Subject: Transmittal of Revision 1 To Service Bulletin Number
V25000-ENG-72-0341

International Aero Engines SERVICE BULLETIN

ENGINE - HP TURBINE ROTOR AND STATOR ASSEMBLY - PROVIDE A NEW STAGE 1 HIGH
PRESSURE TURBINE SUPPORT ASSEMBLY WHICH CONTAINS A NEW SEAL

V2500-ENG-72-0341

Location of the Stage 1 High Pressure Turbine Support Assembly (V2500-A1 Engines)
Figure 1

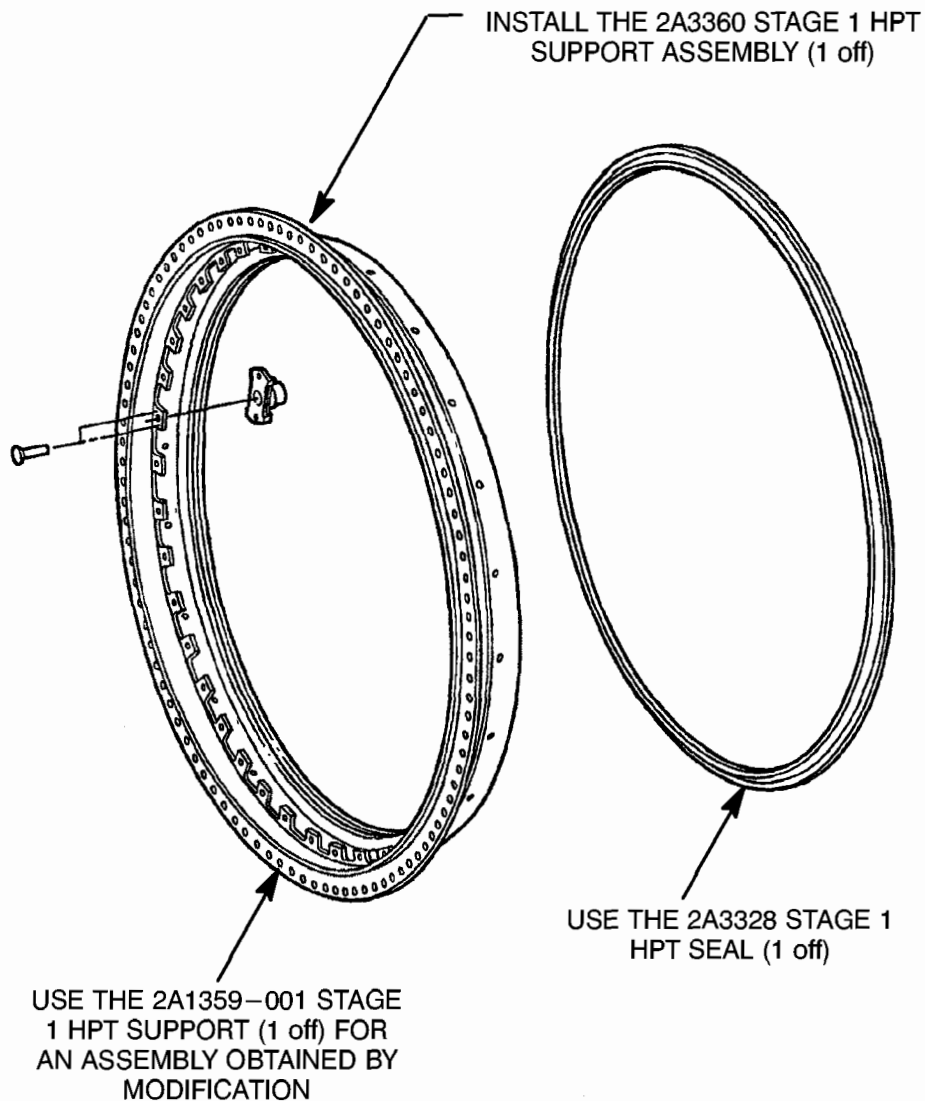
- B. Install the 2A3328 Stage 1 High Pressure Turbine Seal by the procedure specified in Reference (3) or (4) Engine Manual, Chapter/Section 72-44-10, Assembly when you assemble the Stage 1 High Pressure Turbine Support Assembly. See Figures 1 and 2.

- C. Installation Instructions (V2500-A1 Engines)
- (1) Modify the assembly as follows by replacement of detail parts, when you assemble the Stage 1 High Pressure Turbine Support Assembly by the procedure specified in Reference (3) Engine Manual, Chapter/Section 72-44-10 Assembly.

- (a) Replace the non procurable 2A1359 Stage 1 High Pressure Turbine Support with the modified 2A1359-001 Stage 1 High Pressure Turbine Support (1 off)

- (b) Replace the 2A0170 Stage 1 High Pressure Turbine Seal with the 2A3328 Stage 1 High Pressure Turbine Seal (1 off) introduced by V2500-ENG-72-0341.

Location of the Stage 1 High Pressure Turbine Support Assembly (V2500-A5 and V2500-D5 Engines)
Figure 2

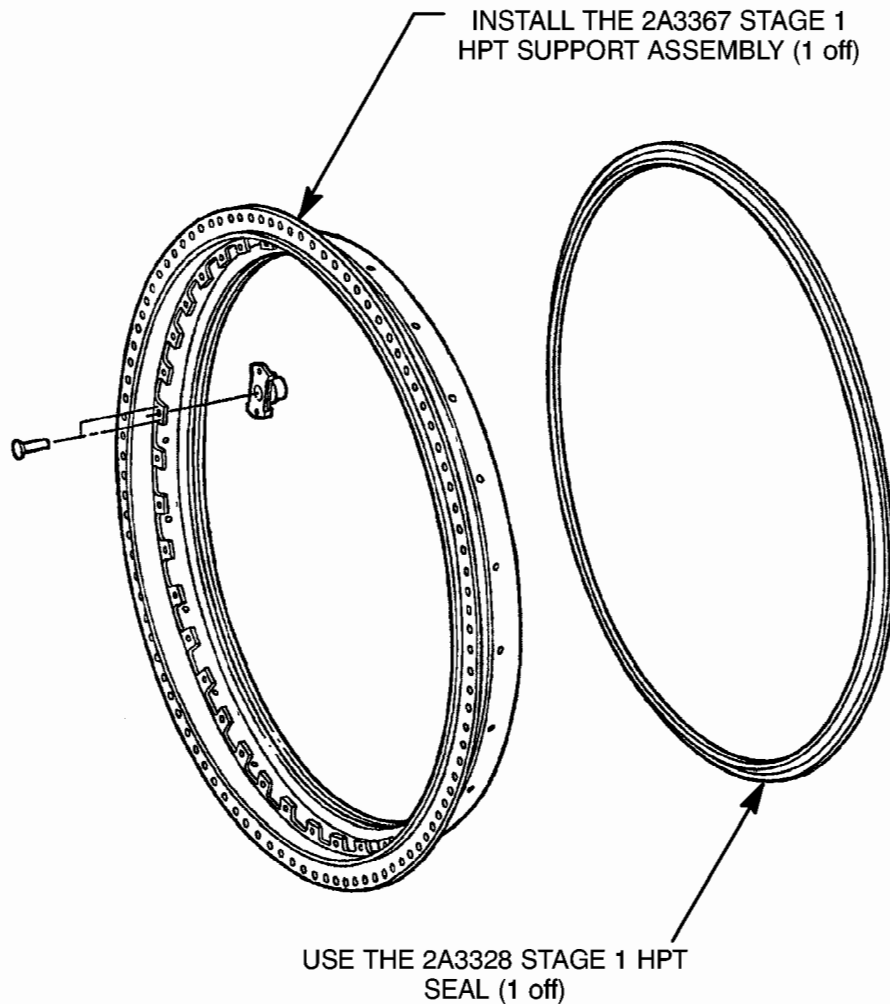
- (1) Replace the 2A2703 Stage 1 High Pressure Turbine Support Assembly with the 2A3367 Stage 1 High Pressure Turbine Support Assembly by the procedure specified in Reference (3) or (4), Engine Manual, Chapter/Section 72-44-00 Assembly. See Figure 2.

Modification of the Stage 1 High Pressure Turbine Vane Support
Figure 3 (Sheet 1)

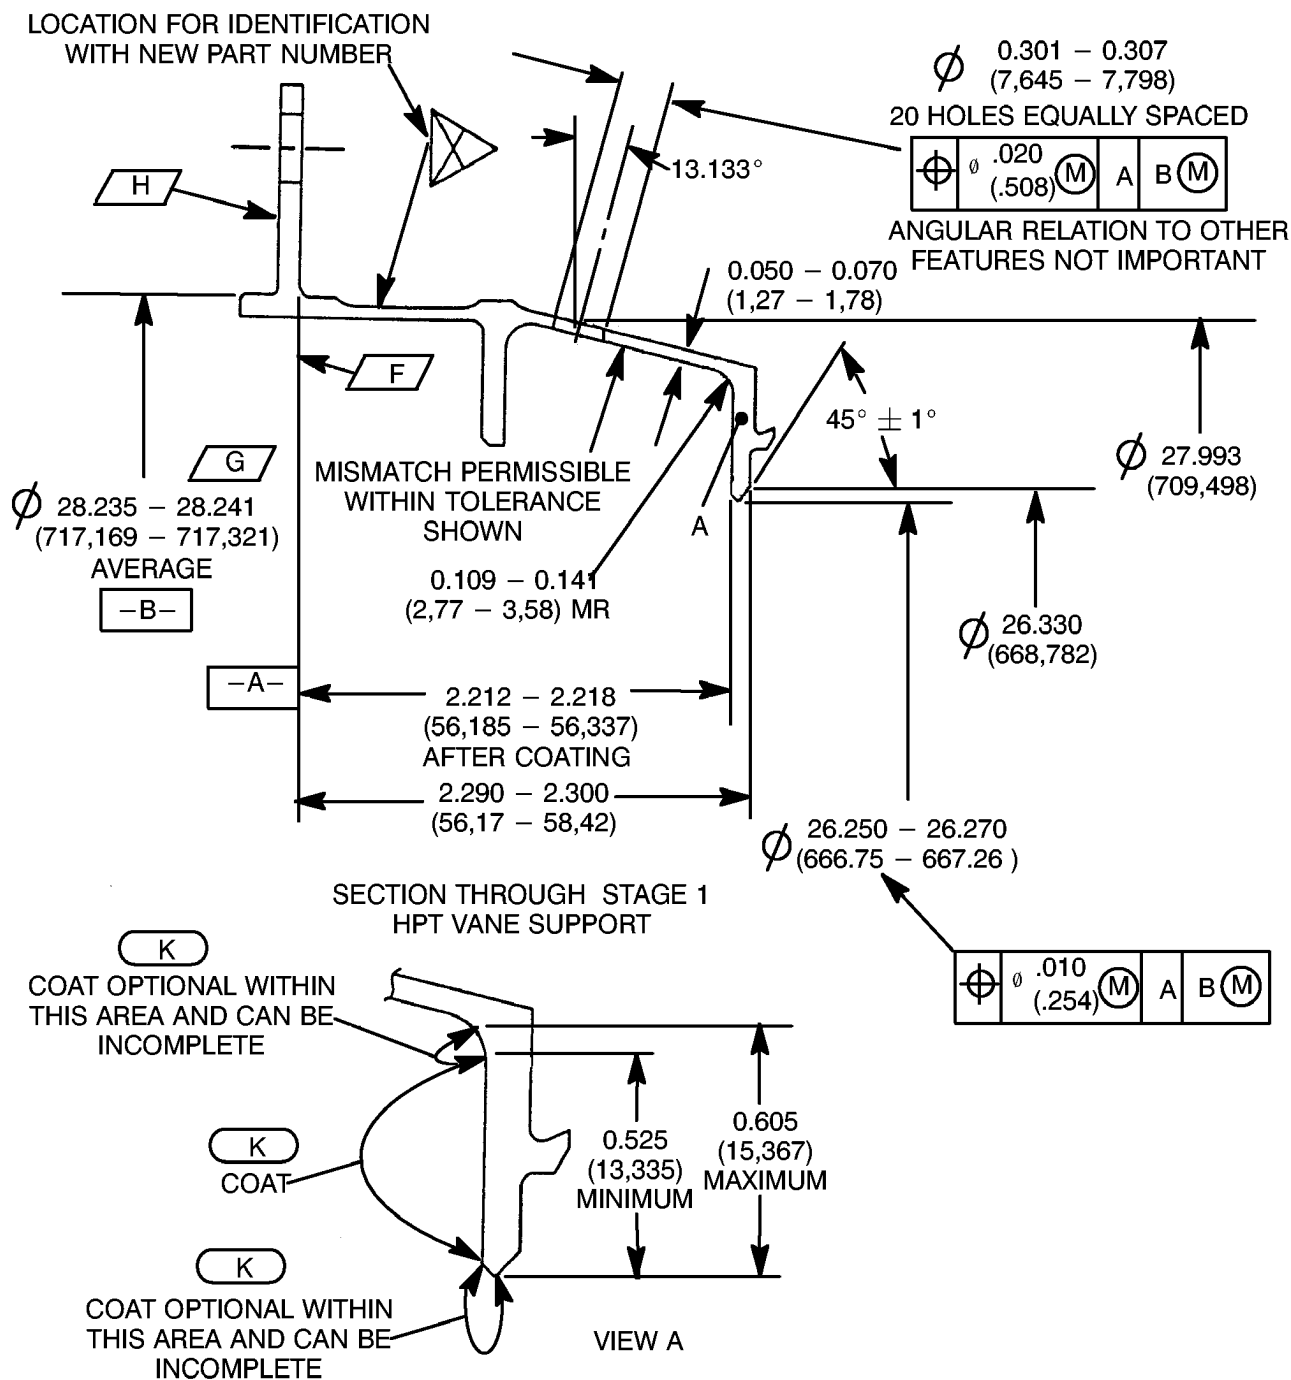
- (a) Machine the non procurable 2A1359 Stage 1 HPT Vane Support as shown in in the referenced figure. Refer to Figure 3.
- (b) Coat the enclosed areas as specified in the procedure given in CONTROL NO./TASK NO. 70-34-03-340-501-002 and the referenced figures. Use the procedure given in specification 53-15. Refer to the procedure given in Reference (4) Chapter/Section 70-34-03, Plasma Spray Application Coating. Refer to Figure 3.

- (c) Mark the new part number adjacent to the existing part number. Use the vibration peen method.
- | <u>Existing</u> | <u>New Part Number</u> |

Use the procedure specified in Reference (4), Chapter/Section 70-09-00, Marking of Parts. See Figure 3 (Sheet 1).

Family Tree - Stage 1 High Pressure Turbine Support Assembly (V2500-A1 Engines)
Ref. Catalog Sequence No 72-44-10. Fig. 1 Item 010
Figure 5

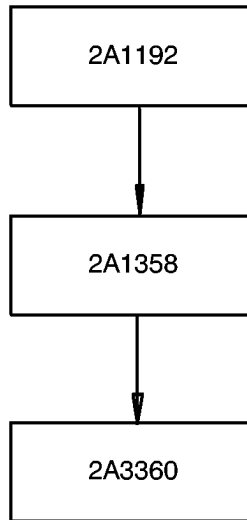
V2500-ENG-72-0341
HP TURBINE ROTOR AND STATOR
ASSEMBLY - PROVIDE A NEW
STAGE 1 HIGH PRESSURE TURBINE
SUPPORT ASSEMBLY WHICH
CONTAINS A NEW SEAL
